Amendment 0003 is hereby incorporated into solicitation SP3100-08-B-5011 and shall become part of any contract.

Amendment 0003 is being issued to answer a vendor question:

1	CHANGED SECURITY FENCE DETAIL	9/17/08
NO.	REVISIONS	DATE
APPROVED BY		DEFENSE LOGISTICS AGENCY
CONSTRUCTION REPRESENTATIVE		DEFENSE DISTRIBUTION DEPOT SUSQUEHANNA, PENNSYLVANIA
ENVIRONMENTAL BRANCH		FACILITIES ENGINEERING DIVISION, ENGINEERING BRANCH
FIRE PROTECTION BRANCH		NEW CUMBERLAND, PA 17070-5002
INDUSTRIAL HYGIENIST		REPLACEMENT TO HVAC
MAINTENANCE OPERATION BRANCH		SYSTEM IN BUILDING 69
ROB MONTEFOUR		DETAILS, SCHEDULES, DIAGRAMS, AND NOTES
FACILITIES ENGINEER		DESIGNED BY: PW/H/GWS
		CHECKED BY:
		PROJECT NO. 3629
		DRAWING NO. M-2
		SHEET 3 OF 3
		DATE JULY 08

SECURITY FENCE DETAIL

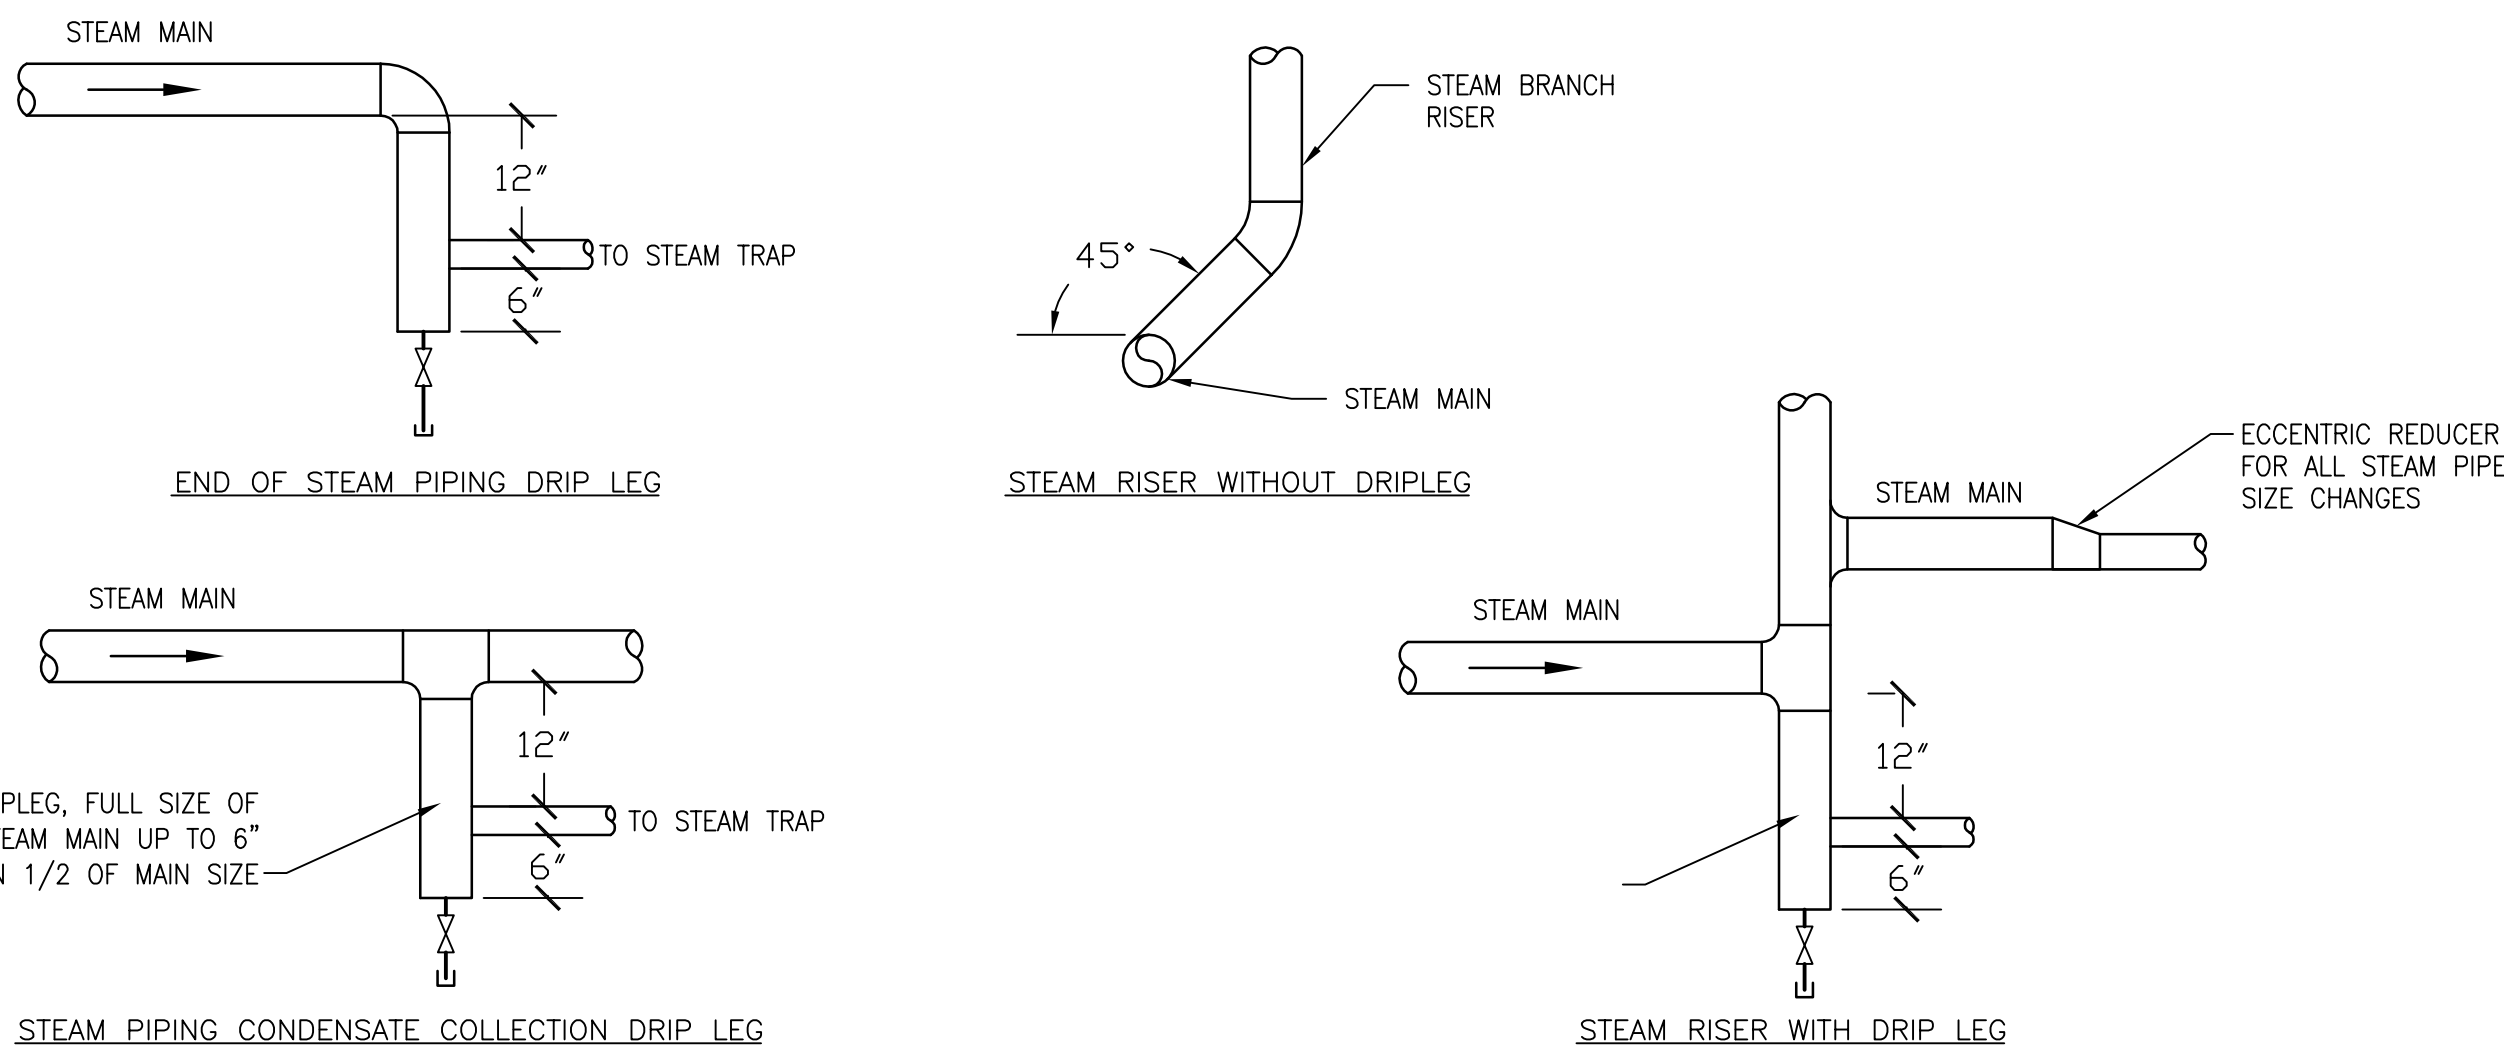
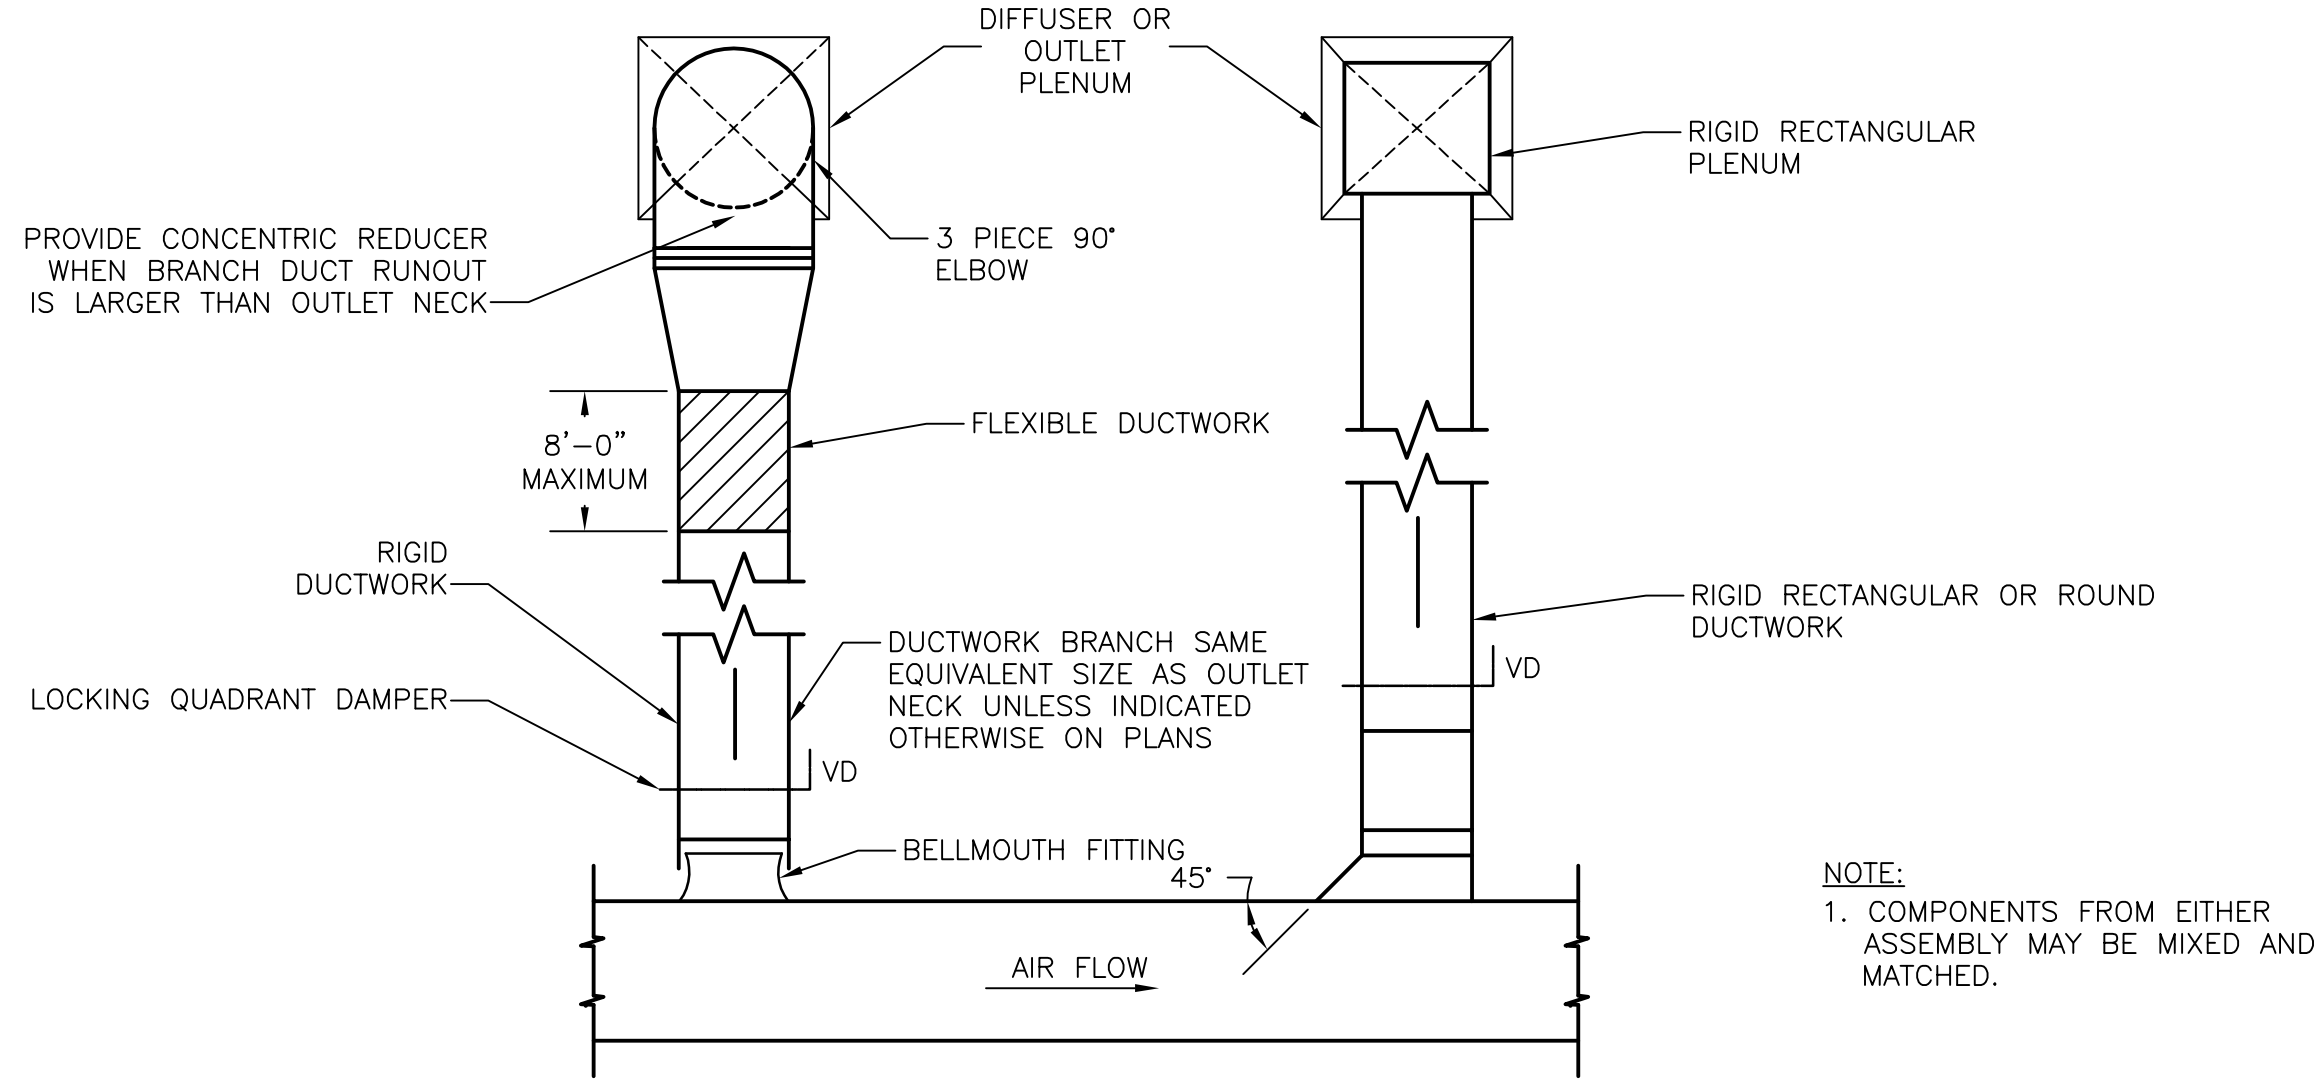
Question #1: Refer to Building 69: On Sheet 2 of 3 under Note 13 it indicates that the chain link fence is to be 8' high, however on Sheet 3 of 3 the details shows 12' high.
Given the height of the gate at 10' high we are assuming that the note is incorrect.

Answer #1: The chain link fence detail on Sheet 3 of 3 of Drawing M-2 is hereby changed to 8' high. See Revisions to attached drawing.
